10419 WILDLIFE RD

APPLICATION FOR APPROVAL TO USE AN EXISTING ON-SITE WASTEWATER TREATMENT & DISPOSAL SYSTEM
MECKLENBURG COUNTY - GROUNDWATER & WASTEWATER SERVICES
700 N. Tryon St., Suite 211 Charlotte, NC 28202
Phone: (704) 336-5103 Fax: (704) 336-6894

FILE #: 5690B

RE: Request for an Improvement Permit for lot 34 at The Sanctuary:
MCHD file # 5690B

Proposed
Retaining
Wall
1/15/09

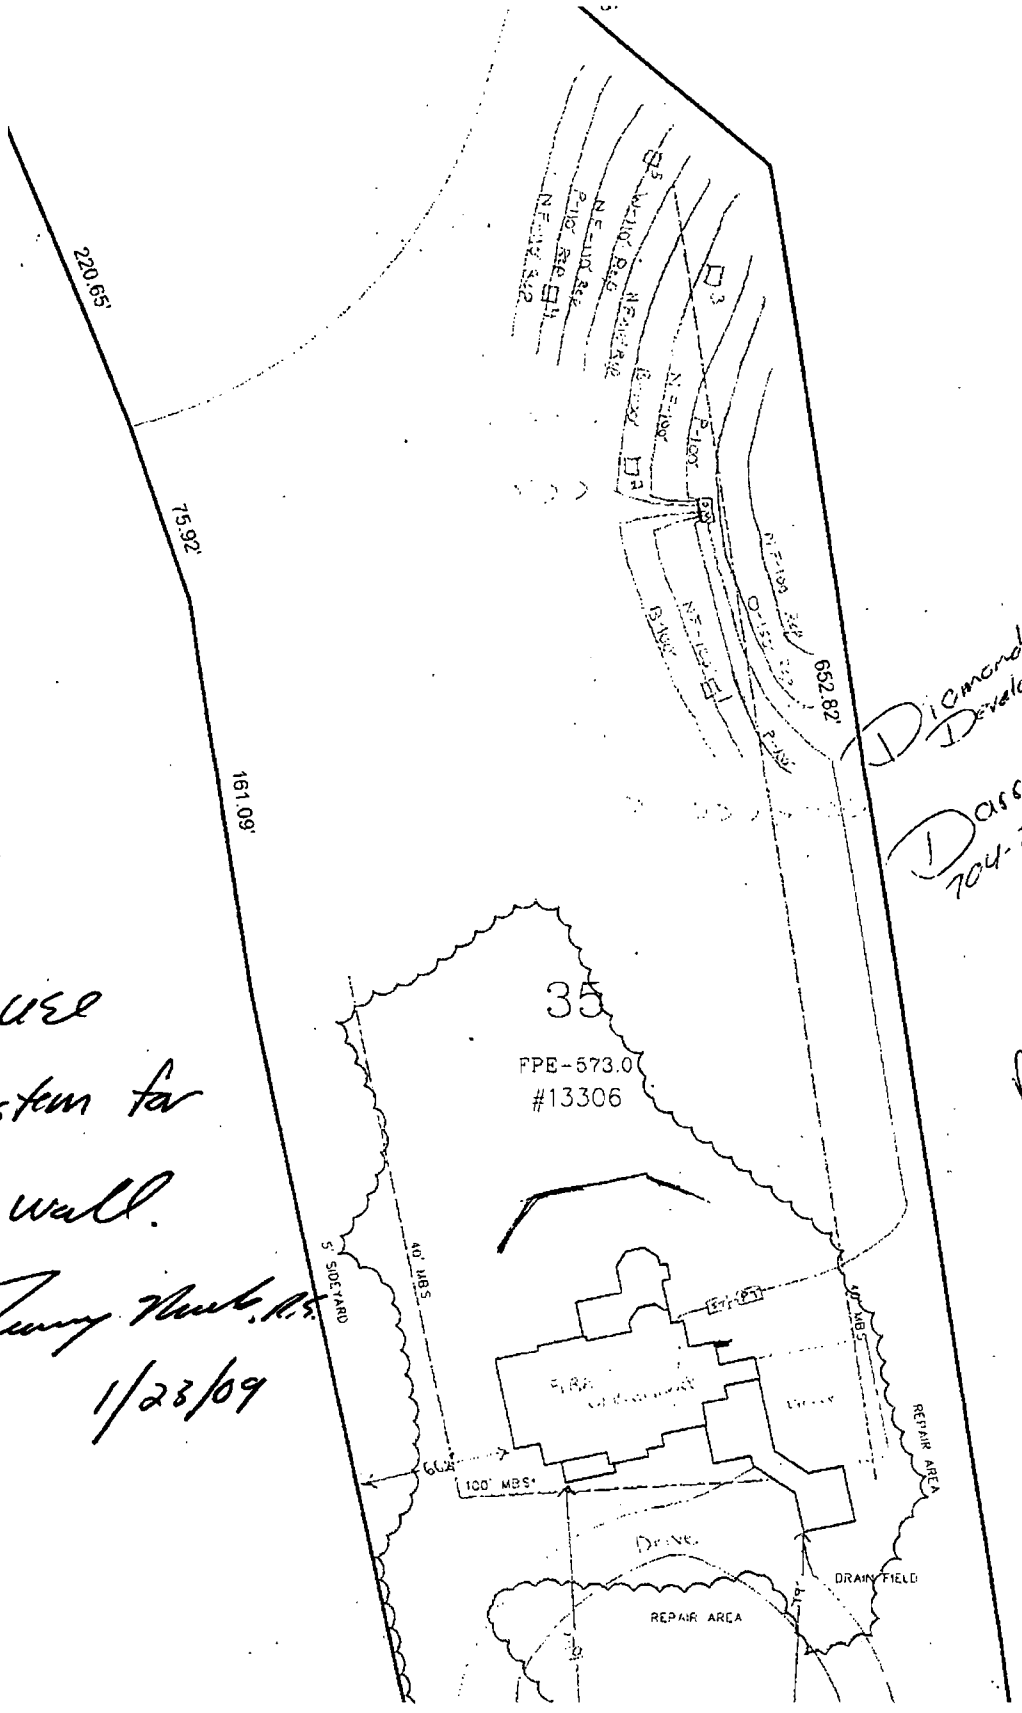
O.K. to use existing system for a retaining wall.
